Report to Planning Committee 5 September 2024  
 Business Manager Lead: Lisa Hughes – Planning Development  
 Lead Officer: Julia Lockwood, Senior Planner, 01636 655902

Report Summary			
<b>Application Number</b>	24/01268/S73		
<b>Proposal</b>	Application for Variation of condition 20 to substitute approved drawings with revised plans for the multi functional building following archaeological investigations attached to planning permission 21/02690/FUL (Engineering works to form new gatehouse approach, alterations to existing castle, creation of new pedestrian access, construction of new entrance pavilion and multi-functional events facility and landscaping works)		
<b>Location</b>	Newark Castle, Castle Gate, Newark- on-Trent		
<b>Applicant</b>	Newark And Sherwood District Council – Steven Chitty	<b>Agent</b>	Lucy Wilson – 5 Bingham Enterprise Centre
<b>Web Link</b>	<a href="https://publicaccess.newark-sherwooddc.gov.uk/online-applications/applicationDetails.do?activeTab=documents&amp;keyVal=SGPSLHLB0BV00">https://publicaccess.newark-sherwooddc.gov.uk/online-applications/applicationDetails.do?activeTab=documents&amp;keyVal=SGPSLHLB0BV00</a>

<b>Registered</b>	17.07.2024	<b>Target D

Newly proposed site layout:

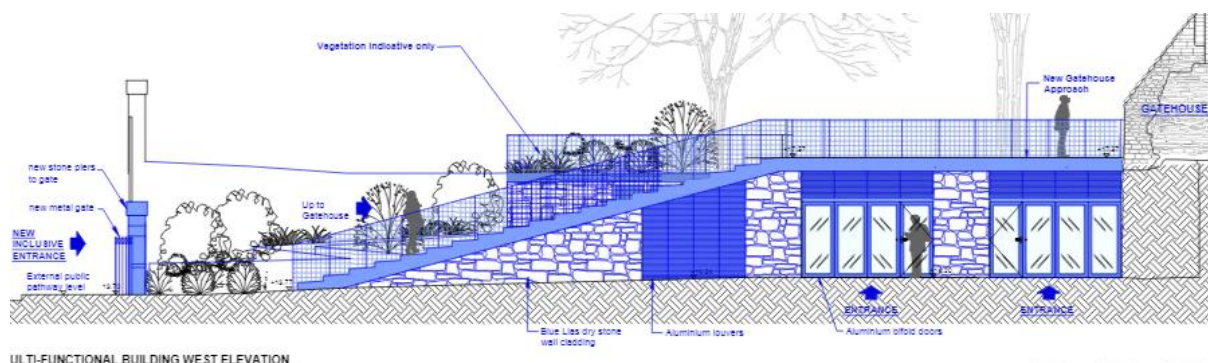
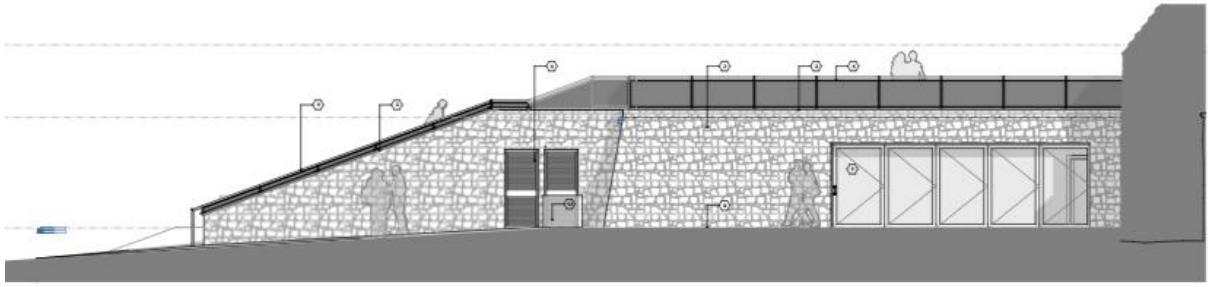
- 3.3 This application seeks a number of amendments to the approved scheme, which are required following archaeological investigations which have identified below ground archaeology whose retention in situ would affect the siting and design of the currently approved scheme. This revised application will ensure that all archaeology discovered can remain in situ adjacent to the multi functional building. It also seeks revision to the design of the pavilion building to improve accessibility, inclusivity, security concerns and limit impacts on the historic fabric.

- The ticket/pavilion building reconfigures the stairs and lift, creating an enclosed core which will improve the visitor reception area and provide better accessibility in adverse weather. It also seeks to address concerns of anti-social behaviour in relation to the previously approved external staircase and reduces visual clutter. There has

Pavilion Building First Floor Plan (as currently approved and then as currently proposed):

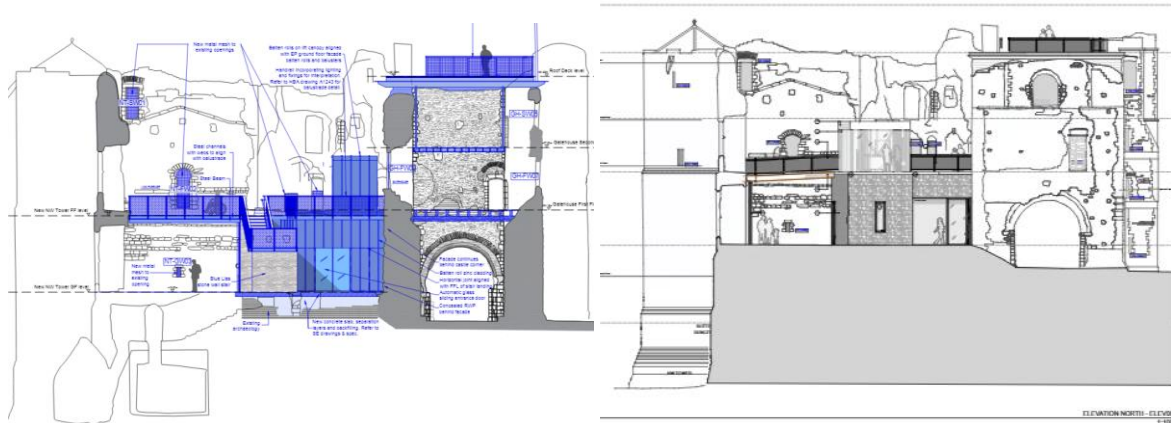
- The ticket/pavilion building reconfigures the stairs and lift, creating an enclosed core which will improve the visitor reception area and provide better accessibility in adverse weather. It also seeks to address concerns of anti-social behaviour in relation to the previously approved external staircase and reduces visual clutter. The proposed floor level has been raised (by approx. 200mm) and allows a fully level deck (with no stepped platform) creating a single accessible deck from the Gatehouse to the North-East Tower. The existing roof that abuts the main building will be fixed to the masonry using traditional lead flashing tying into existing mortar courses. In terms of materials, the previously approved zinc cladding has been removed and replaced with the Cadeby stone.
